3/4.2.3 AZIMUTHAL POWER TILT - T_q

FIGURE 3.2 - 1A
AZIMUTHAL POWER TILT LIMIT
VS
THERMAL POWER
(COLSS IN SERVICE)

PALO VERDE - UNIT 1

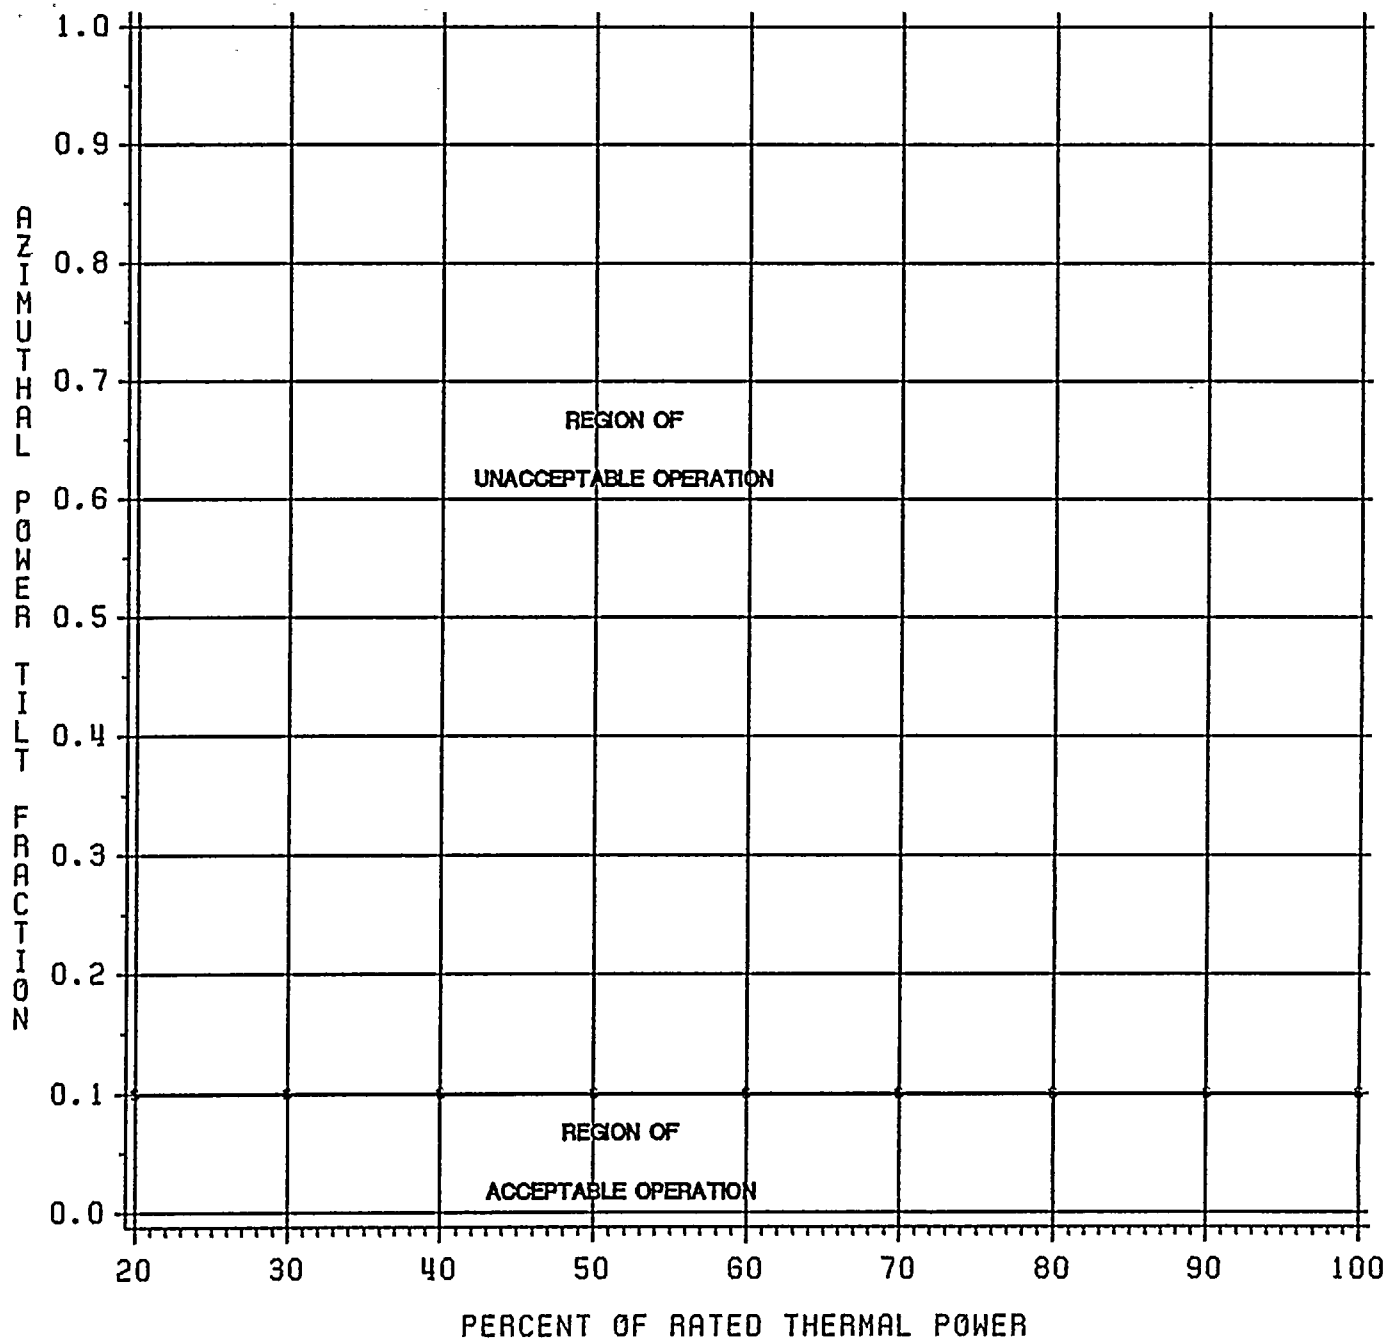
3.2.3 The AZIMUTHAL POWER TILT (T_q) shall be less than or equal to the AZIMUTHAL POWER TILT Allowance used in the Core Protection Calculators (CPCs) following limits:

4.2.3.2 The AZIMUTHAL POWER TILT shall be determined to be within ^{its} ~~the~~ limits above 20% of RATED THERMAL POWER by:

- a. Continuously monitoring the tilt with COLSS when the COLSS is ^{in service,} ~~OPERABLE~~.
- b. Calculating the tilt at least once per 12 hours when the COLSS is ~~inoperable.~~ ^{out of service.}
- c. Verifying at least once per 31 days, that the COLSS Azimuthal Tilt Alarm is actuated at an AZIMUTHAL POWER TILT less than or equal to the AZIMUTHAL POWER TILT Allowance used in the CPCs.
- d. Using the incore detectors, at least once per 31 EFPD to independently confirm the validity of the COLSS calculated AZIMUTHAL POWER TILT.

The limit in Figure 3.2-1A with COLSS in service or 0.10 with COLSS out of service.

FIGURE 3.2 - 1A
AZIMUTHAL POWER TILT LIMIT
VS
THERMAL POWER
(COLSS IN SERVICE)

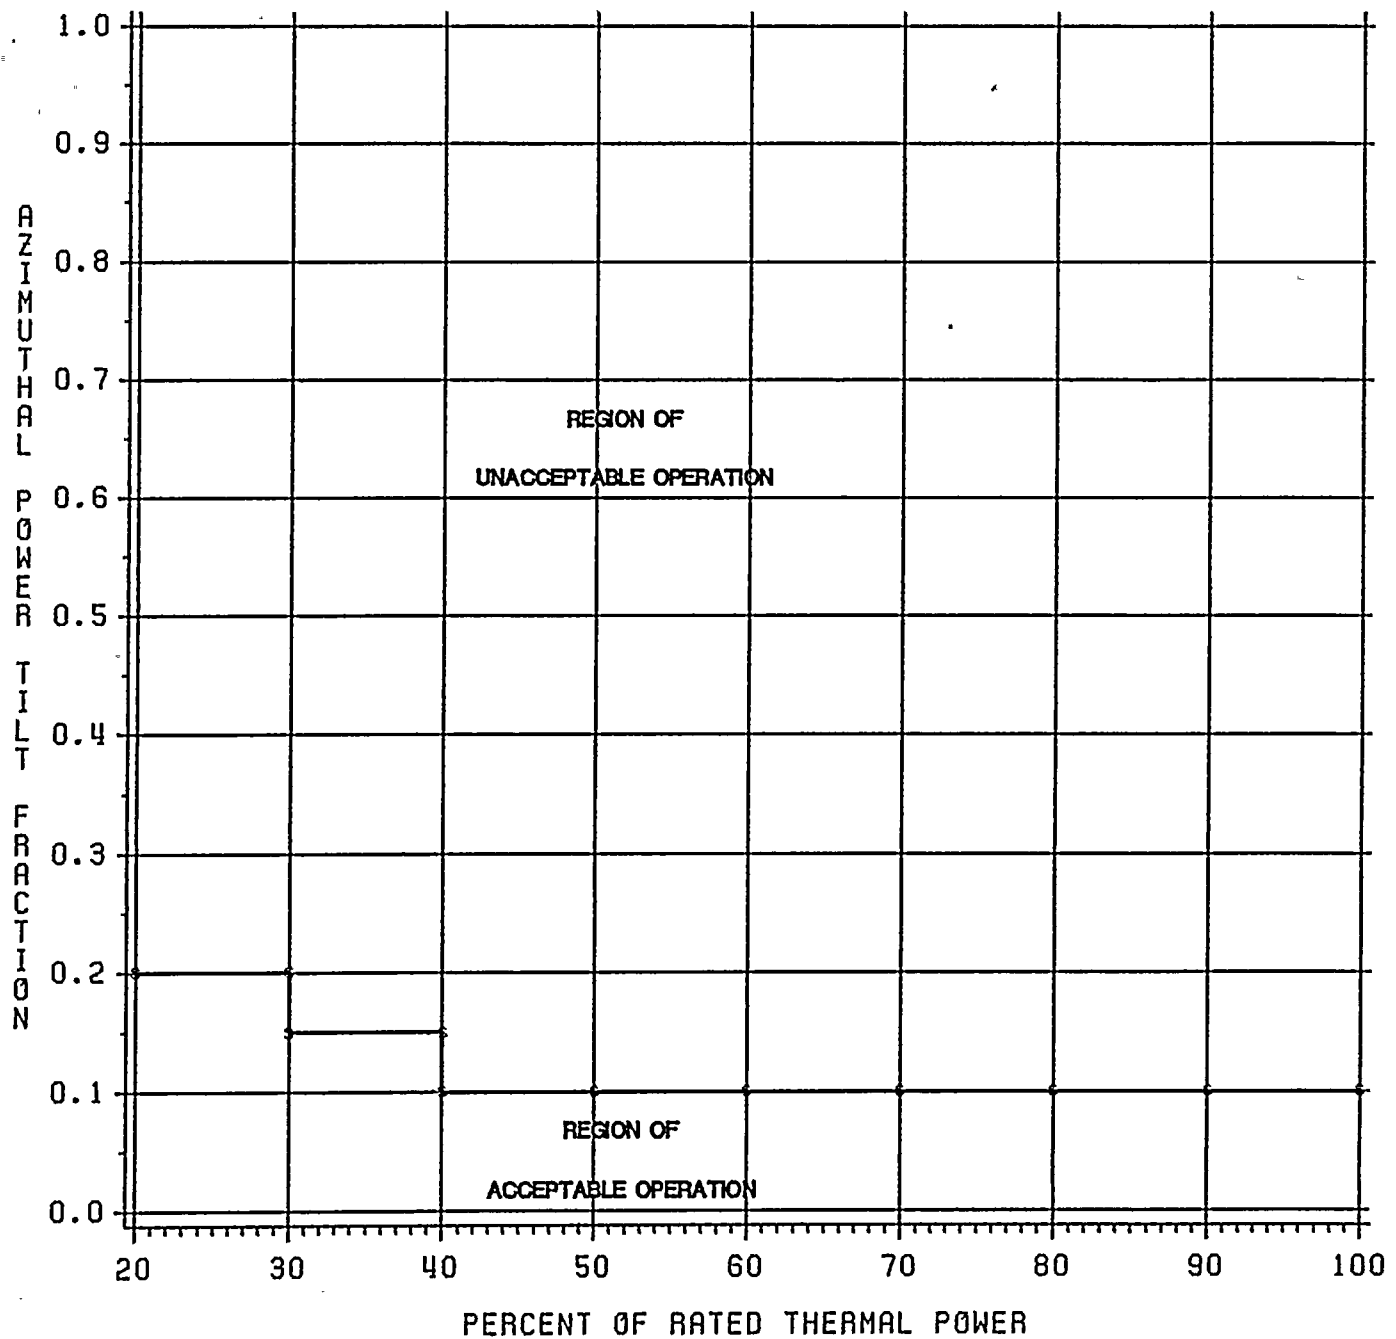
3.2.3 The AZIMUTHAL POWER TILT (T_q) shall be less than or equal to the ~~AZIMUTHAL POWER TILT Allowance used in the Core Protection Calculators (CPCs)~~. following limits:

- a. The AZIMUTHAL POWER TILT Allowance used in the Core Protection Calculators (CPCs), and
 - b.1. The limit in Figure 3.2-1A with COLSS in service, or
 - b.2. $T_q \leq 0.10$ with COLSS out of service.

- a. With the measured AZIMUTHAL POWER TILT determined to exceed the AZIMUTHAL POWER TILT Allowance used in the CPCs ~~but less than or equal to 0.10~~, within 2 hours either correct the power tilt or adjust the AZIMUTHAL POWER TILT Allowance used in the CPCs to greater than or equal to the measured value.

4.2.3.2 The AZIMUTHAL POWER TILT shall be determined to be within ^{its} ~~the~~ limits [^] above 20% of RATED THERMAL POWER by:

- a. Continuously monitoring the tilt with COLSS when the COLSS is ^{in service} ~~operable~~.
- b. Calculating the tilt at least once per 12 hours when the COLSS is ~~inoperable~~ out of service.
- c. Verifying at least once per 31 days, that the COLSS Azimuthal Tilt Alarm is actuated at an AZIMUTHAL POWER TILT less than or equal to the AZIMUTHAL POWER TILT Allowance used in the CPCs.
- d. Using the incore detectors at least once per 31 EFPD to independently confirm the validity of the COLSS calculated AZIMUTHAL POWER TILT.

the limit in Figure 3.2-1A with COLSS in service or 0.10 with COLSS out of service.

FIGURE 3.2 - 1A
AZIMUTHAL POWER TILT LIMIT
VS
THERMAL POWER
(COLSS IN SERVICE)

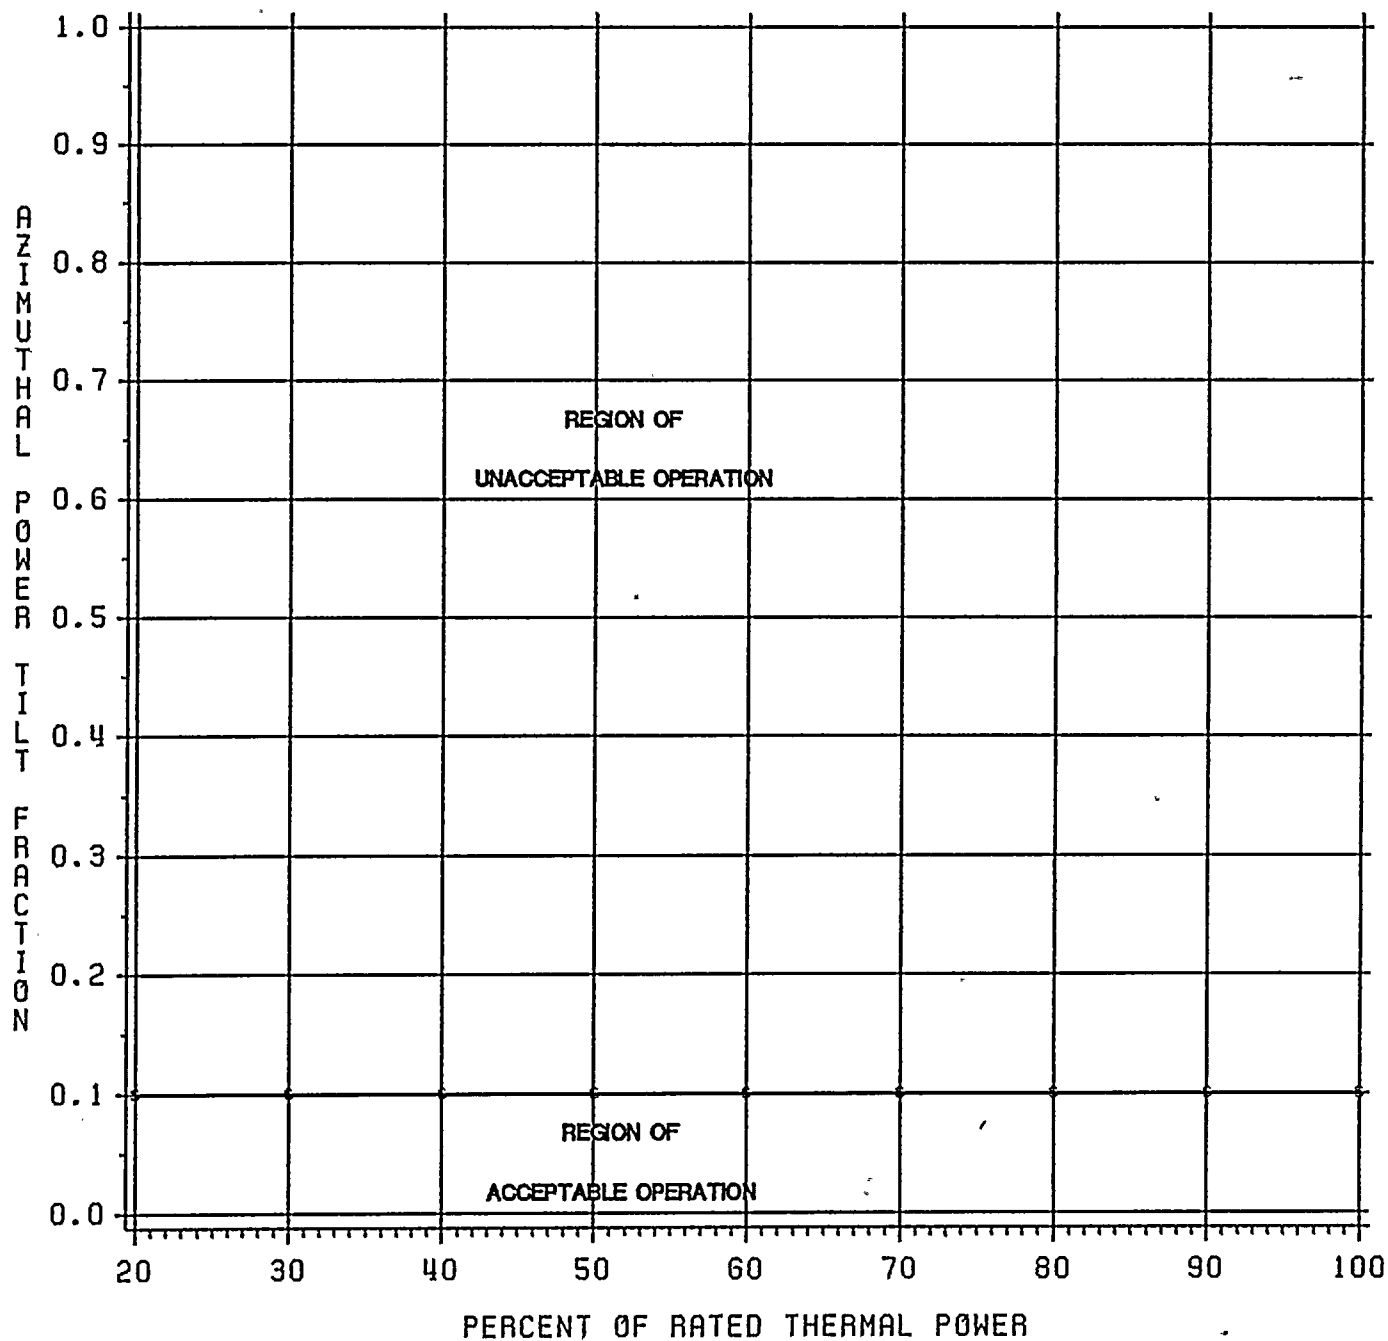
- a. The AZIMUTHAL POWER TILT Allowance used in the Core Protection Calculators (CPCs), and
b.1. The limit in Figure 3.2-1A with COLSS in service, or
b.2. $T_q \leq 0.10$ with COLSS out of service.

4.2.3.2 The AZIMUTHAL POWER TILT shall be determined to be within ^{its} ~~the~~ limits above 20% of RATED THERMAL POWER by:

- a. Continuously monitoring the tilt with COLSS when the COLSS is ^{in service,} ~~OPERABLE~~.
- b. Calculating the tilt at least once per 12 hours when the COLSS is ~~inoperable,~~ out of service,
- c. Verifying at least once per 31 days, that the COLSS Azimuthal Tilt Alarm is actuated at an AZIMUTHAL POWER TILT less than or equal to the AZIMUTHAL POWER TILT Allowance used in the CPCs.
- d. Using the incore detectors at least once per 31 EFPD to independently confirm the validity of the COLSS calculated AZIMUTHAL POWER TILT.

The limit in Figure 3.2-1A with COLSS in service or 0.10 with COLSS out of service.
